SUBJECT: SUSQUEHANNA STEAM ELECTRIC STATION, UNITS 1 AND 2 -
AUTHORIZED ALTERNATIVE TO REQUIREMENTS OF THE ASME CODE
(EPID L-2023-LLR-0027)

**SAFETY EVALUATION BY THE OFFICE OF NUCLEAR REACTOR REGULATION FOR
RELIEF REQUEST 5RR-02 (PROPOSED ALTERNATIVE)
FIFTH 10-YEAR SNUBBER PROGRAM INTERVAL
FIFTH 10-YEAR INSERVICE INSPECTION INTERVAL
SUSQUEHANNA NUCLEAR, LLC
ALLEGHENY ELECTRIC COOPERATIVE, INC.
SUSQUEHANNA STEAM ELECTRIC STATION, UNIT 1 AND UNIT 2
DOCKET NOS. 50-387 and 50-388**

Figure 2 Proposed Alternative Examination Boundaries

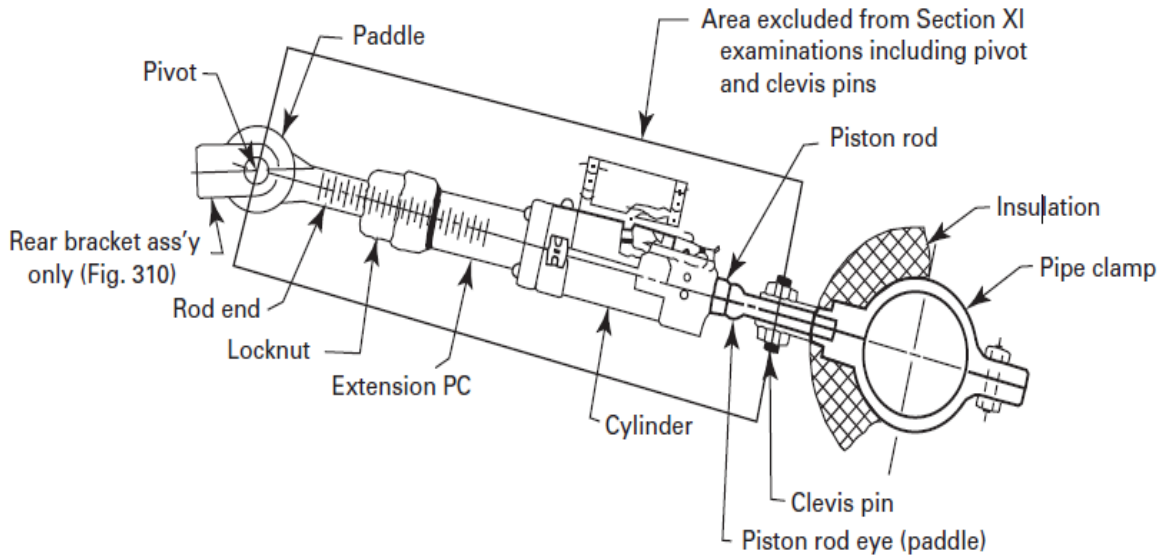
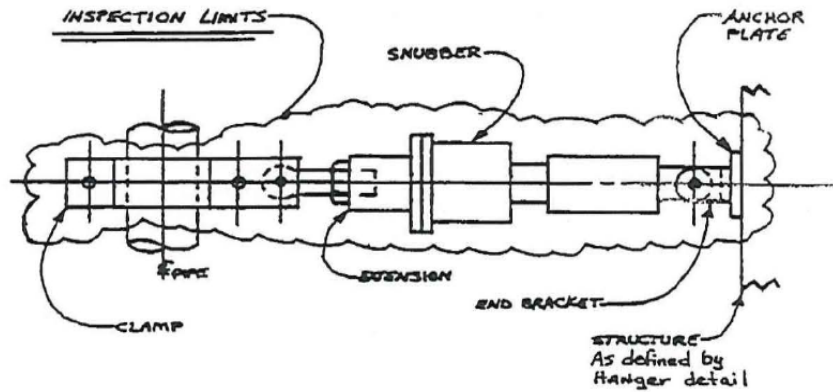
The ASME BPV Code, Section XI, Figure IWF-1300-1(f) depicts the examination boundaries for a snubber, as shown in figure 1. The boundaries indicate that the attachment of the snubber to the pressure boundary and building structure is required to be examined in accordance with Article IWF-2000, whereas the excluded snubber (pin-to-pin) is required to be examined per the ASME OM Code.

To eliminate the duplication of effort by tracking two different examination boundaries for one component (snubber and its attachment and associated support), the licensee requested an alternative to establish one examination boundary, as shown previously in figure 2. Incorporating both examination boundaries into one program would also provide a better understanding of the condition of the snubber and its associated attachment to the pressure boundary or building structure.

The NRC staff reviewed the information provided in licensee's submittal, as supplemented. The staff finds the proposed examination boundaries of snubbers and attachments as shown in figure 2, in lieu of the boundaries shown in figure 1, are acceptable for the following reasons:

- (1) Incorporating both examination boundaries (snubbers and their attachments and associated supports) into one program provides a better understanding of the condition of a snubber and its associated attachments, without impacting quality and safety.

- (2) The licensee stated that it will use VT-3 qualified personnel for both snubbers and associated attachments and supports. Performing both visual examinations of a snubber and its attachments and supports under the proposed boundaries in the snubber program using VT-3 qualified personnel to perform examinations provides a better understanding of the snubber and attachments.

- (3) ASME BPV Code Section XI did not specify the boundaries between a snubber and its attachments and supports. In the 2006 Addenda of the ASME BPV Code, Section XI, the new boundaries between the snubber and its attachments were introduced via Figure IWF-1300-1(f) because the snubber (pin-to-pin) examination and testing were moved to the ASME OM Code. Visual examination of snubber attachments by VT-3 qualified personnel meets the inspection requirement of ASME BPV Code, Section XI.

- (4) The licensee stated that the station meets the provisions in section 2 of ASME OM Code Case OMN-13. Furthermore, the licensee stated that, as specified in section 3.7(b) of ASME OM Code Case OMN-13, if the number of unacceptable snubbers exceed the limits in prescribed in ASME OM Code, Table ISTD-4252-1, then the frequency interval of visual examinations will be reduced for snubber examination (i.e., the examinations would occur more frequently).

- (5) ASME OM Code Case OMN-13 requires 100 % of safety-related snubbers to be examined and evaluated at least once every 10 years. Based on the proposed boundaries of figure 2, the licensee will also perform 100 % visual examination of snubber attachments along with the snubbers. This exceeds the requirements of the ASME BPV Code, Section XI, Table IWF-2500-1 (for attachments), which only specifies that 25 % of Class 1, 15 % of Class 2, and 10 % of Class 3 supports be inspected over a 10-year interval.

- (6) Visual examination of the snubber and associated attachments would be performed at the same time.

Based on the above, the NRC staff finds that the licensee's proposed alternative of boundaries as specified in figure 2, which includes the snubber and its attachments, meets or exceeds the inspection requirements of ASME BPV Code, Section XI, Article IWF-2000 and, therefore, provides an acceptable level of quality and safety. The NRC staff also finds it acceptable for the licensee to track snubber attachment inspections via the station's snubber program in lieu of the ISI program.
